Re: PETITION NO. 1609 – TRITEC Americas, LLC notice of election to waive exclusion from Connecticut Siting Council jurisdiction, pursuant to Connecticut General Statutes §16-50k(e), and petition for a declaratory ruling, pursuant to Connecticut General Statutes §4-176 and §16-50k, for the proposed construction, maintenance and operation of a 0.999-megawatt AC solar photovoltaic electric generating facility located at 250 Carter Street, Manchester, Connecticut, and associated electrical interconnection.
Petitioner Responses to Interrogatories from Council.

Petition No. 1609

**TRITEC Americas, LLC
250 Carter Street, Manchester, Connecticut**

**Interrogatories
April 2, 2024**

Sheet Title:	SITE LAYOUT PLAN
Sheet #:	2.11

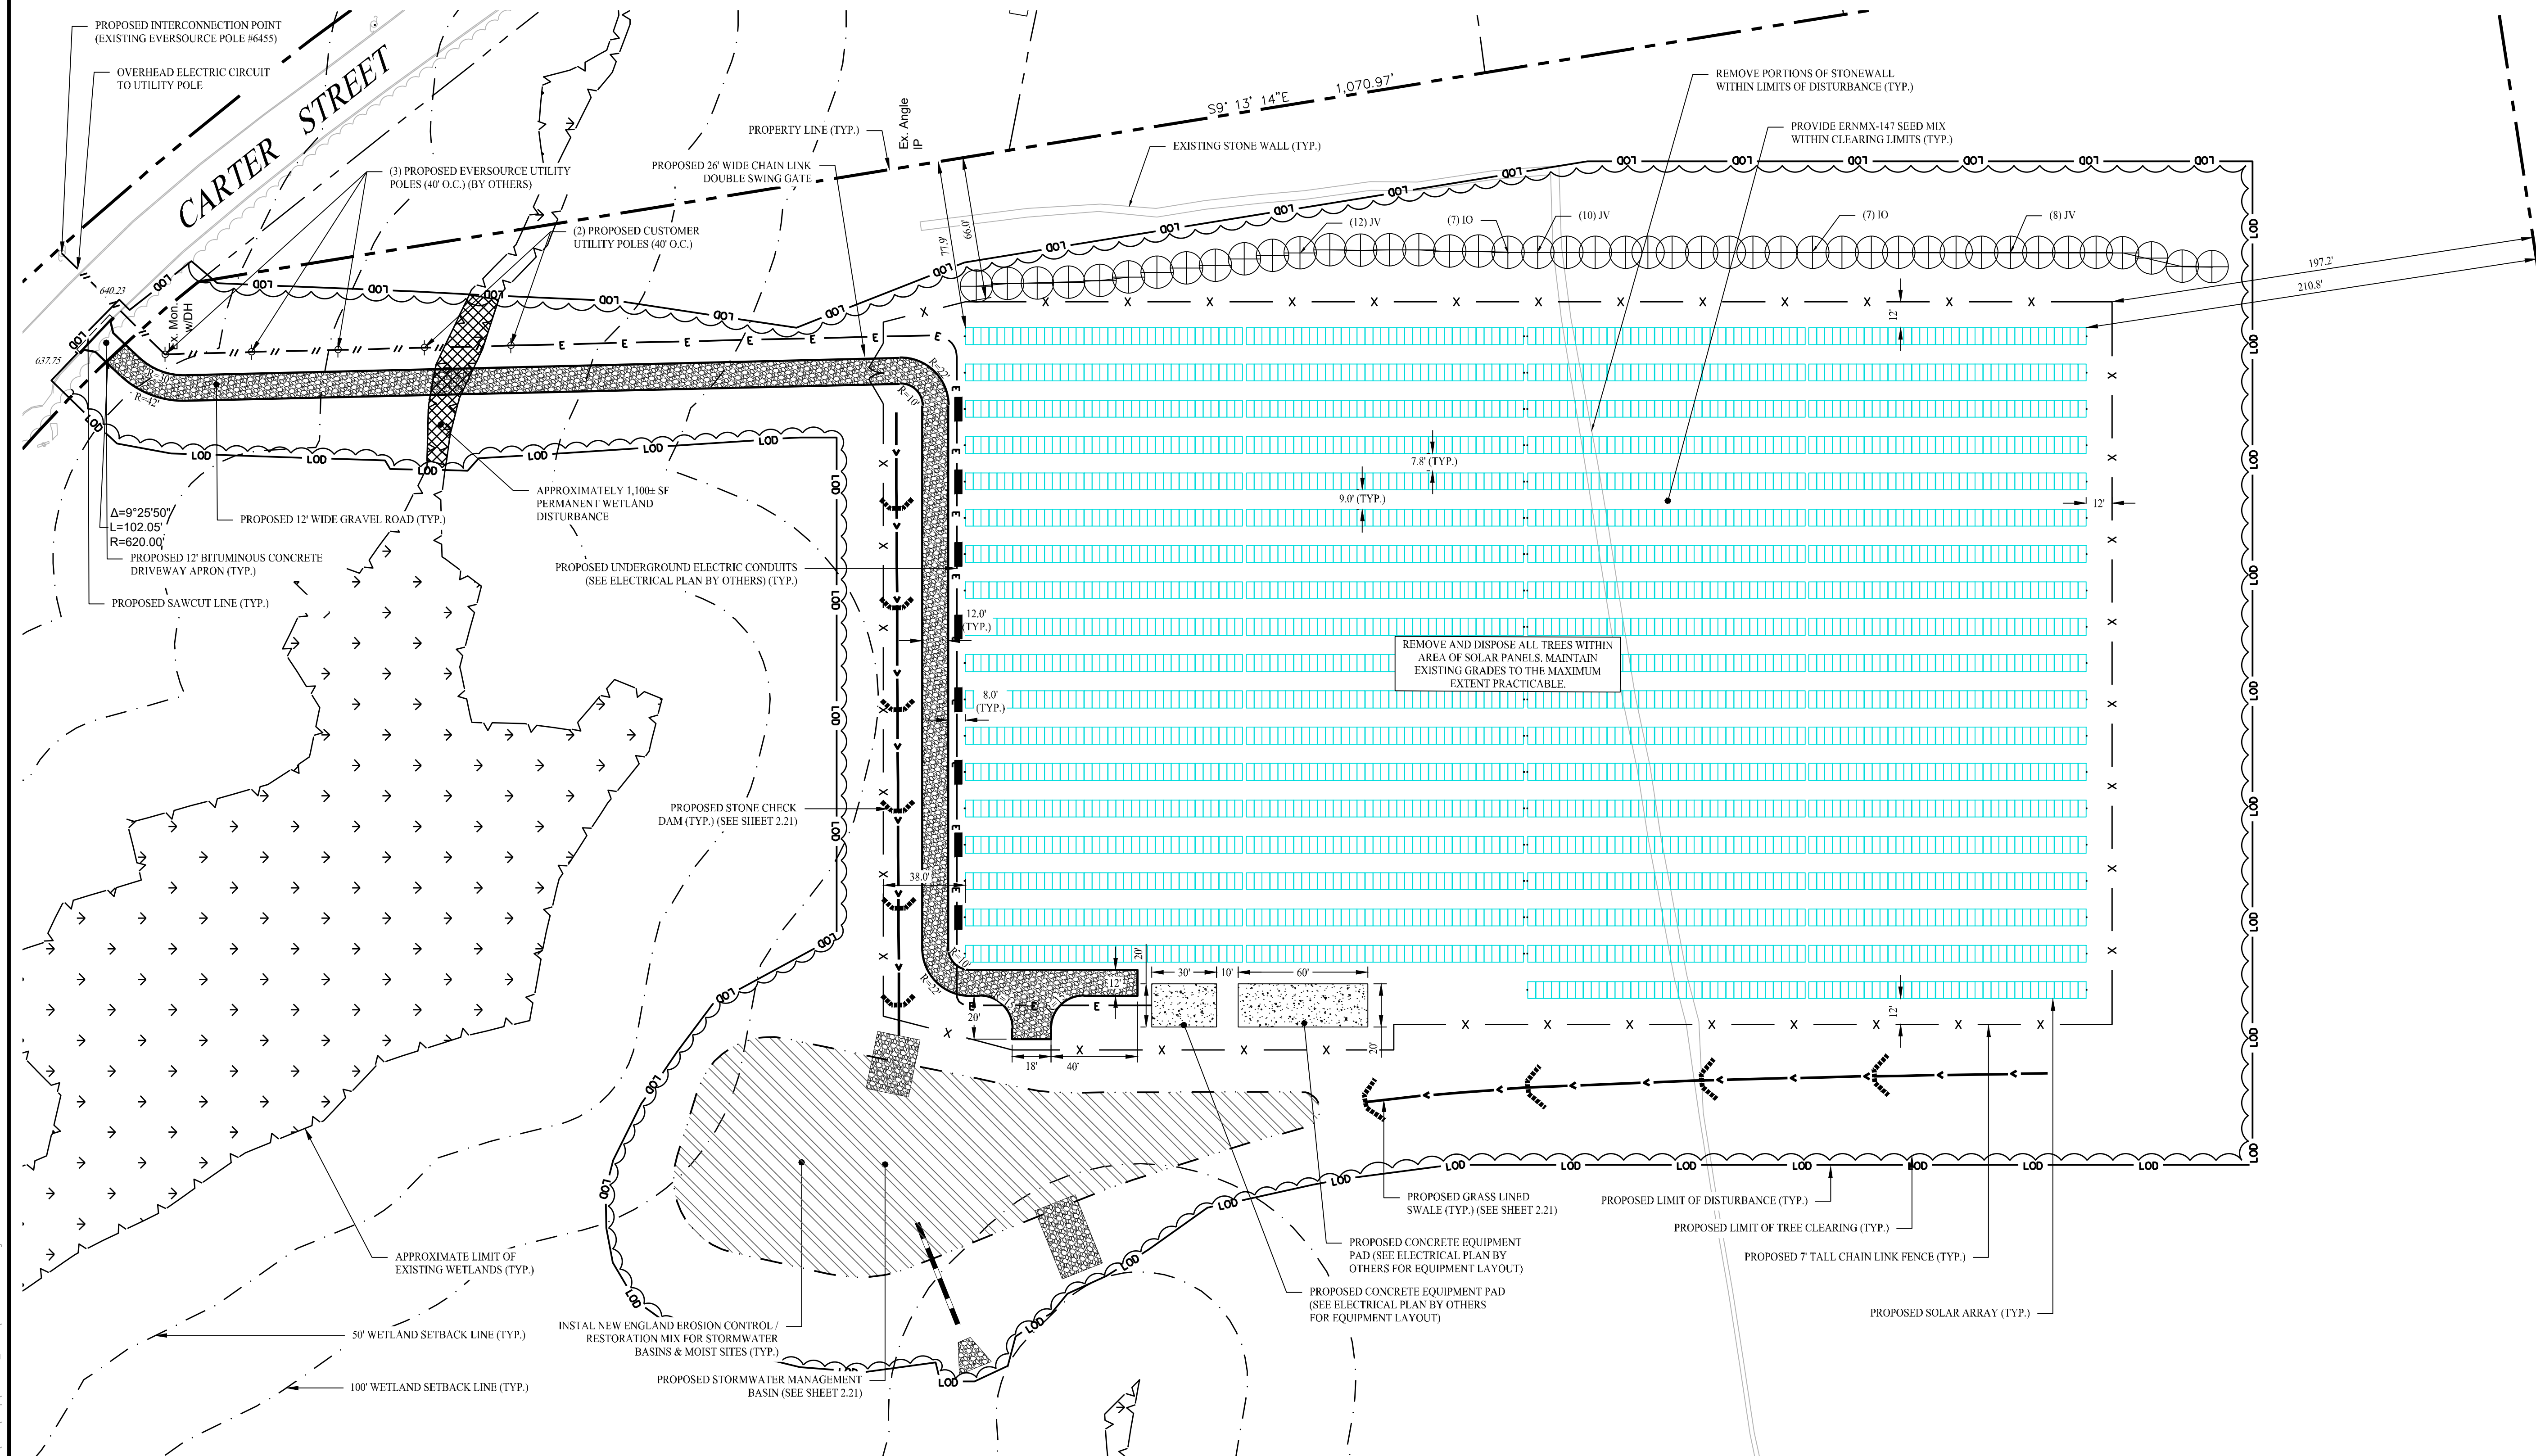
31. Referencing Petition Site Plan 2.11, six proposed utility poles are shown; however, five are described in Petition Exhibit G, p. 3. Clarify.

32. Referencing Petition Site Plan 2.11, what equipment would be installed on each utility pole? Can the number of poles be reduced by consolidating equipment?

Five utility poles are required: three Eversource-owned poles and two customer-owned poles. The plans have been revised accordingly and are attached herein. See “Exhibit B: Revised Civil Plan Drawing Set.”

Sheet Title:	SOIL EROSION & SEDIMENT CONTROL PLAN PHASE I	Sheet #:	2.31
--------------	--	----------	------

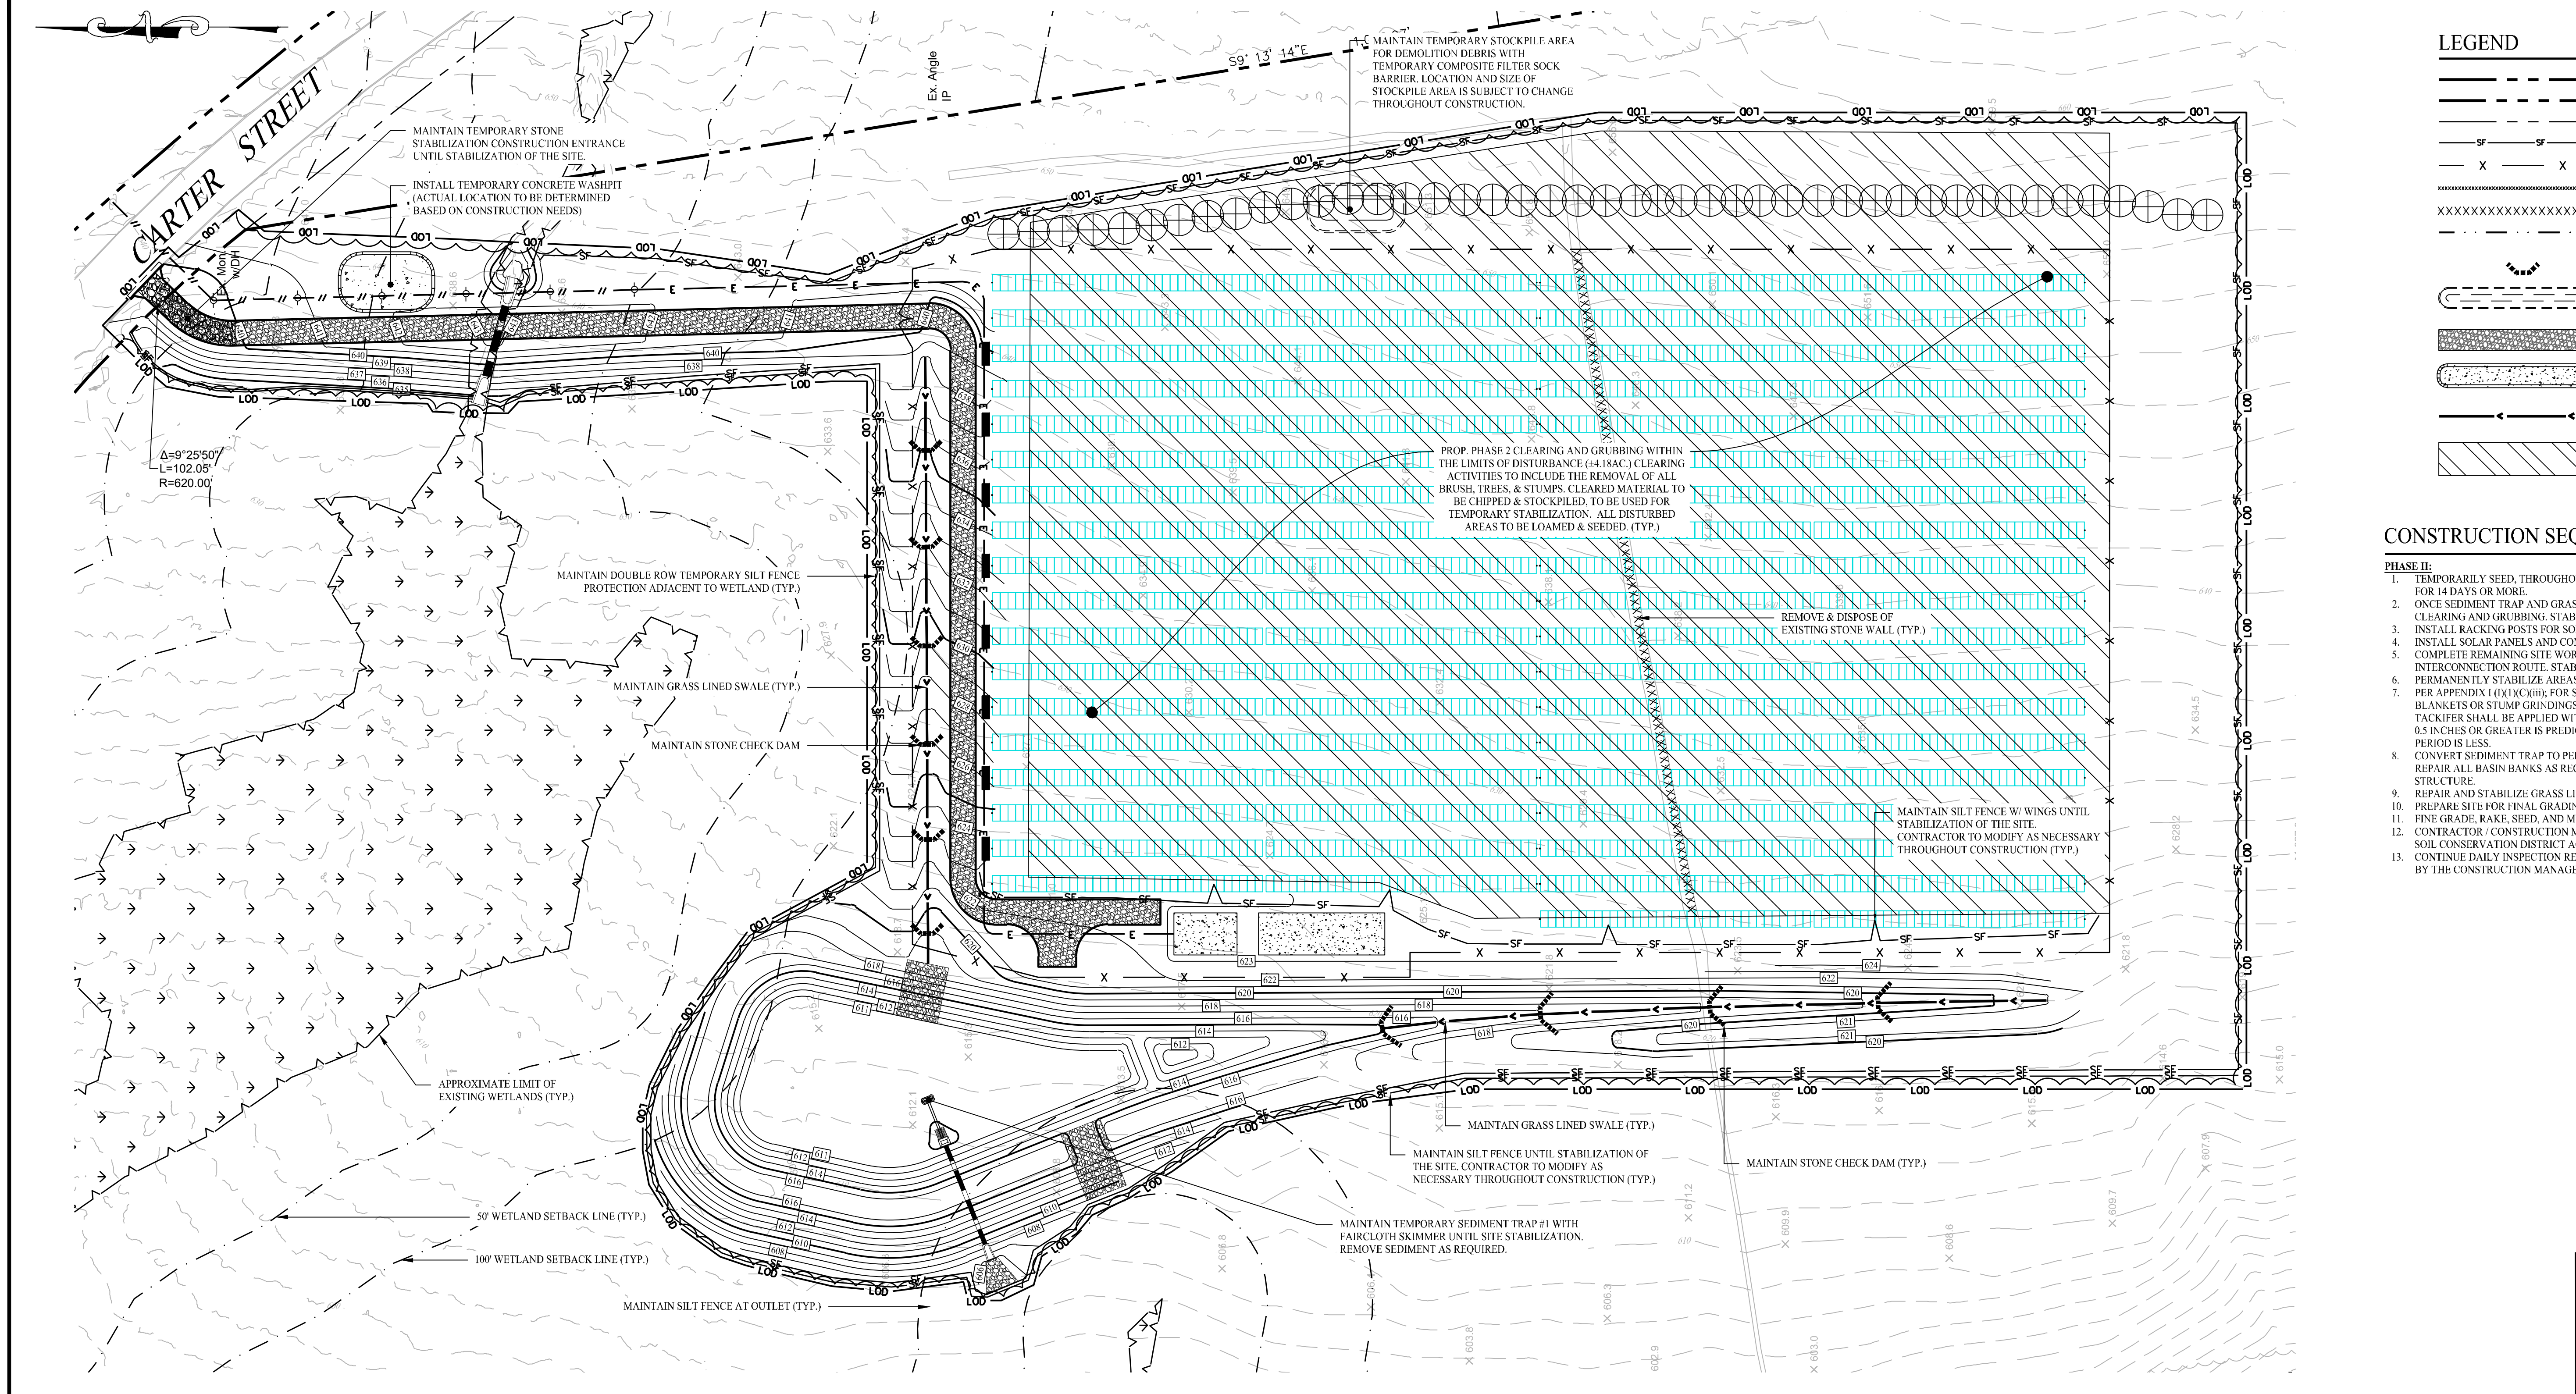
47. Referencing Petition Site Plan 2.31, Note 1, is the preliminary design of the Project at least 50 percent complete? If not, would construction comply with the *Connecticut Soil Erosion and Sediment Control Guidelines* and *Connecticut Stormwater Quality Manual*, effective March 30, 2024?

Design and construction will comply with the 2024 Connecticut Soil Erosion and Sediment Control Guidelines and the 2024 Connecticut Stormwater Quality Manual. The notes on the plans have been updated and are attached herein. See “Exhibit B: Revised Civil Plan Drawing Set.”

7' HIGH CHAIN LINK FENCE DETAIL

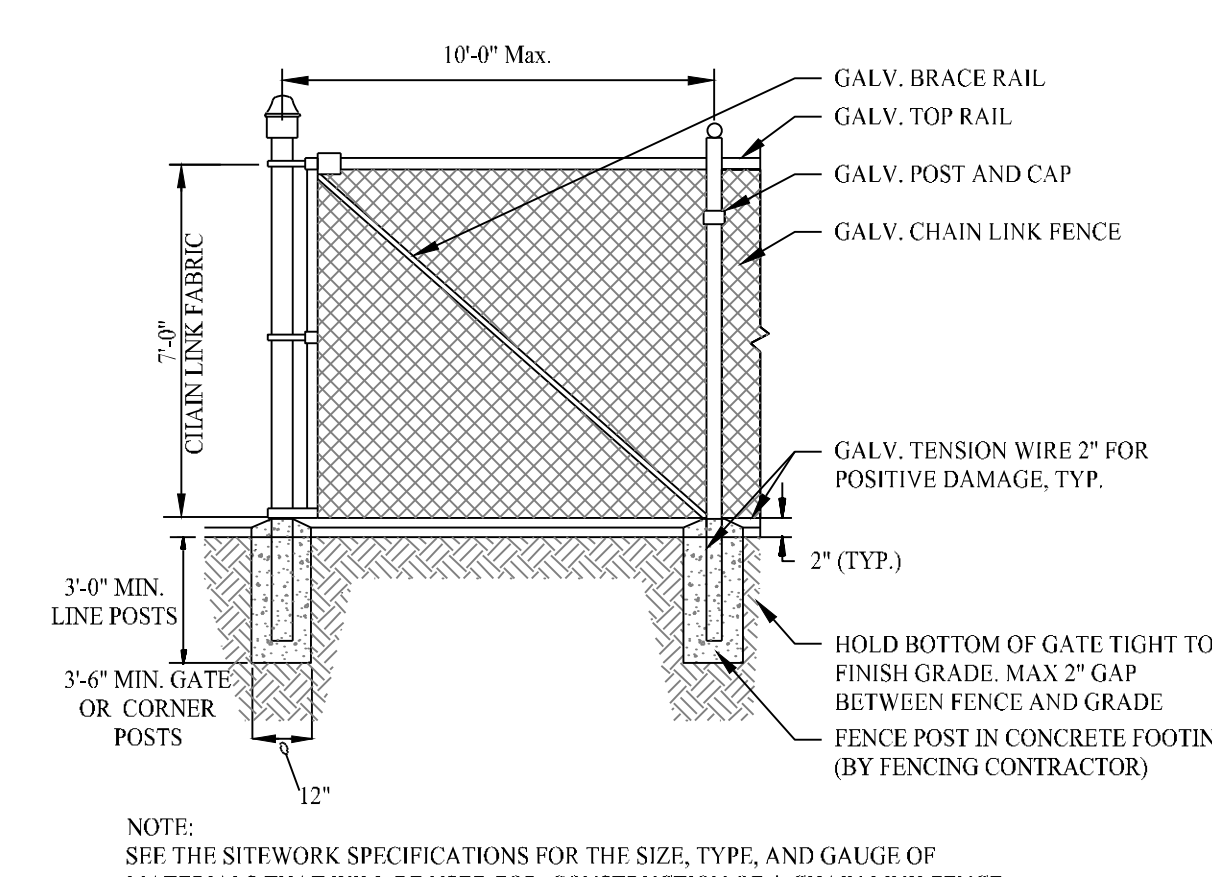
53. Referencing Petition Site Plan 3.01—Fence Detail, can the bottom of the perimeter fence fabric be raised to six inches above grade to allow for small wildlife movement?

The details have been revised accordingly to provide a six-inch gap for small wildlife movement and are attached herein. See “Exhibit B: Revised Civil Plan Drawing Set.”
